Technical Service Bulletin

69 PODS component replacement information

69 20 50 2059223/1 April 24, 2020.

Figure 3. PODS sensor mat listed separately in ETKA (+MY19 Q3).

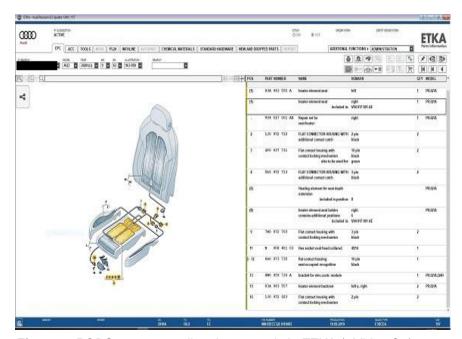
In ETKA, PODS components are listed individually if a PODS Kit is not offered.

Tip: At the time of publishing, PODS control modules were not available individually yet. Please check your parts department for availability. If the PODS control module has to be replaced and cannot be ordered, it might be necessary to order and replace an entire seat.
